ADDENDUM # 1

RFQ# 7459253

**Title: REPLACE ROOFING AT ZAMBARANO POWER PLANT
BID CLOSING DATE: February 18, 2013 AT 10:00 AM (EST)**

**Replace Roofing on Zambarano Power Plant – RFQ # 7459253
Answers to Questions Asked at Pre-bid Visit on January 31, 2013**

ATTACHMENT 2

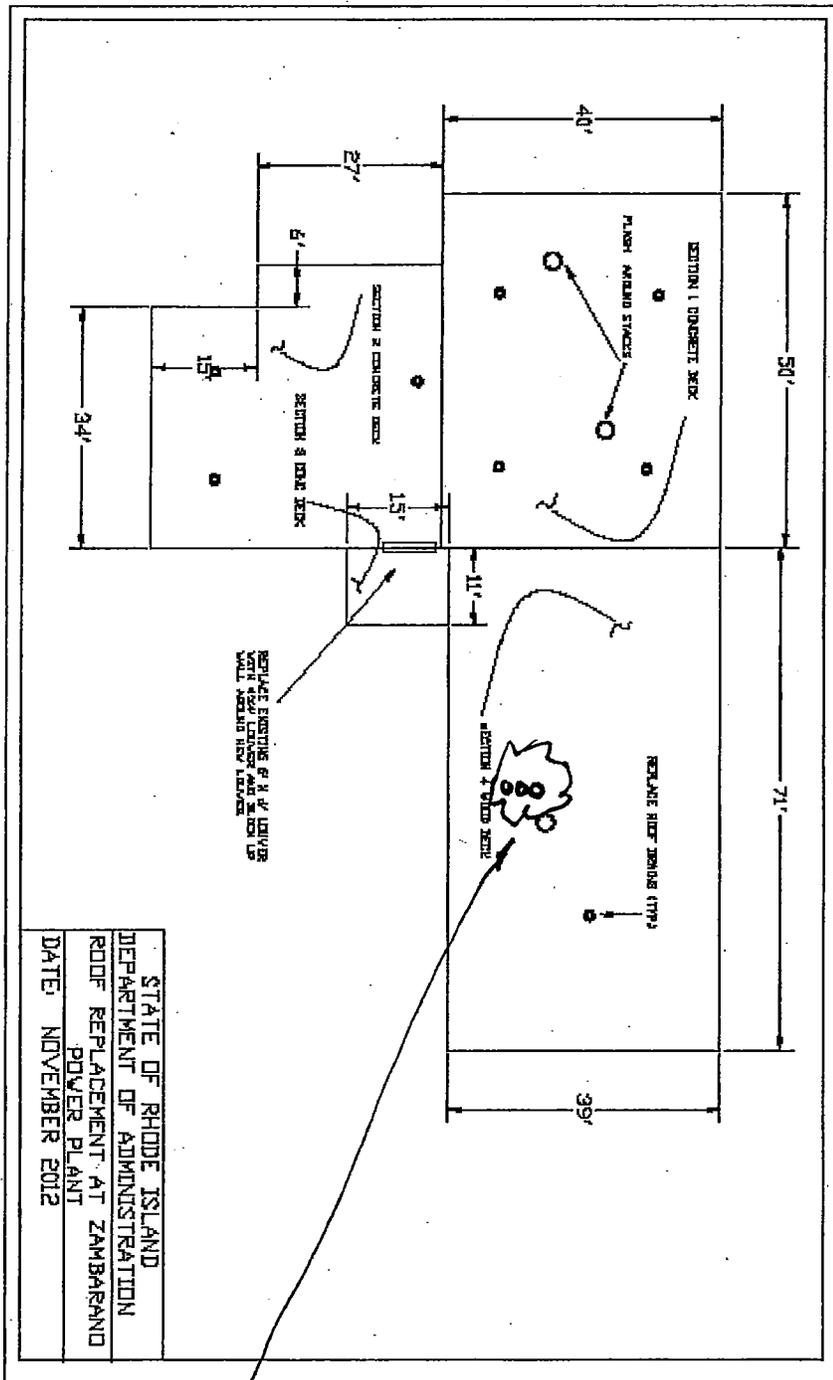
4 Would the State accept one layer of 3.3" thick rigid isocyanurate foam in lieu of the 3.25" foam specified in the RFQ.	Alternative insulation materials proposed will be subject to review and approval by the State. Such approval will not be unreasonably withheld if the the substitute material has structural and insulation properties equivalent to the RFQ, and is approved by the manufacturer of the roofing membrane system.
5 Is there an allowance for replacement of rotted roof decking?	Contractors are requested to provide a unit cost per square foot *a* for replacement of wood decking with material of like dimension to the existing. If repairs to the concrete decking are required they will be handled as a change order. *b*
6 Are all existing stacks to remain.	There is a cluster of 3 stacks identified on Attachment 2 that must be removed. The roof decking that is penetrated by these stacks is to be replaced.

Remove 3 Stacks, and replace affected decking
